PLAN COMMISSION AGENDA

TO: Village of Pewaukee Plan Commission
CC: Matt Heiser – Village Administrator, Jenna Peter - Clerk
FROM: Mark Lyons, Planning Consultant
RPT DATE: October 2, 2025
MTG DATE: October 9, 2025
RE: Christian Brothers Automotive CUG – Conditional Use Grant and Business Site Plan / Plan of Operation for an Automotive Service Use.

RE: Christian Brothers Automotive Site Plan Review – Capitol Drive, Pewaukee, WI 53072

TO: Village of Pewaukee Plan Commission
CC: Matt Heiser – Village Administrator, Jenna Peter - Clerk
FROM: Mark Lyons, Planning Consultant
RPT DATE: October 2, 2025
MTG DATE: October 9, 2025
RE: Bubble’s Foam Farm –Planned Unit Development Request

SITE LAYOUT PLAN

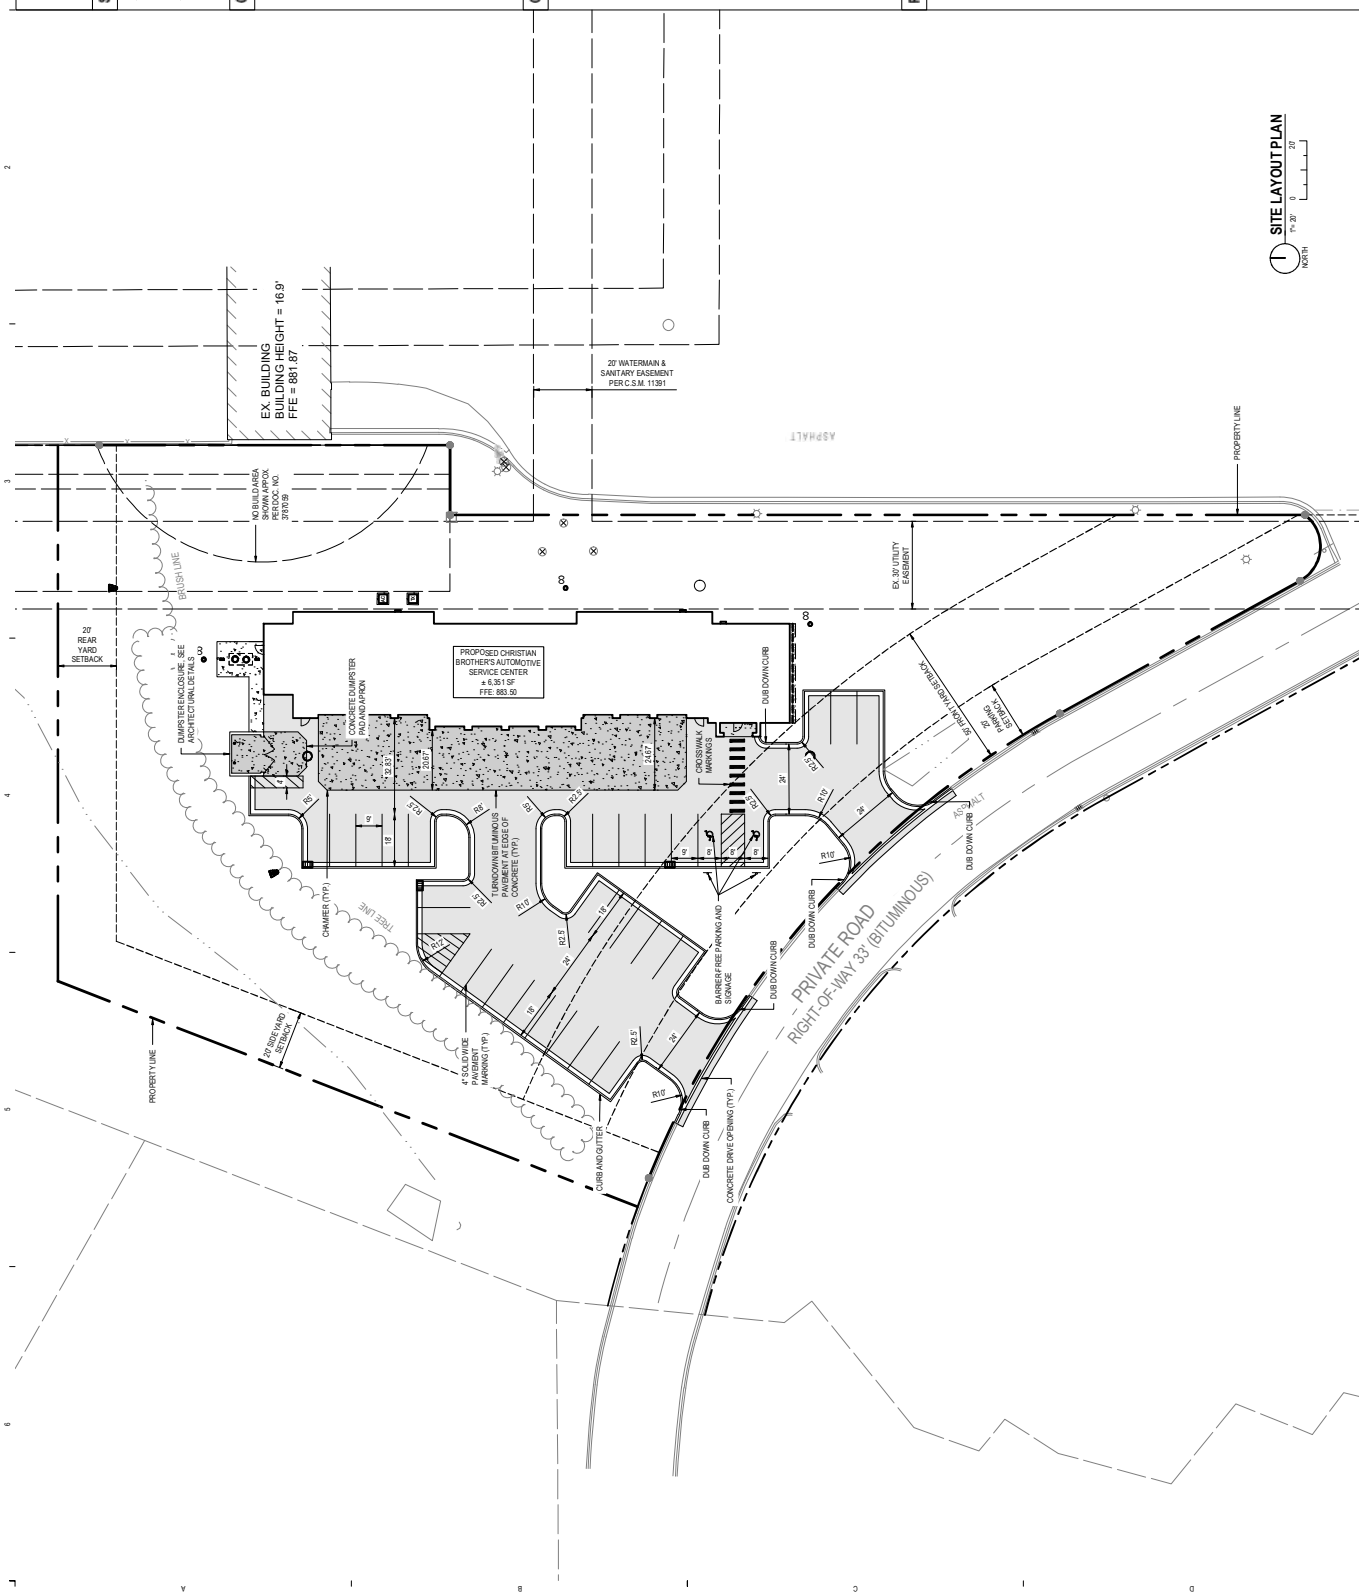
Sheet C201 – Site Layout Plan

11. Clarify or provide a detail for “DUB DOWN CURB”.
12. The drive aisle width in the west parking lot does not meet the minimum width per the Village Code. Revise the westerly parking lot to include a minimum drive aisle width of 25 feet.
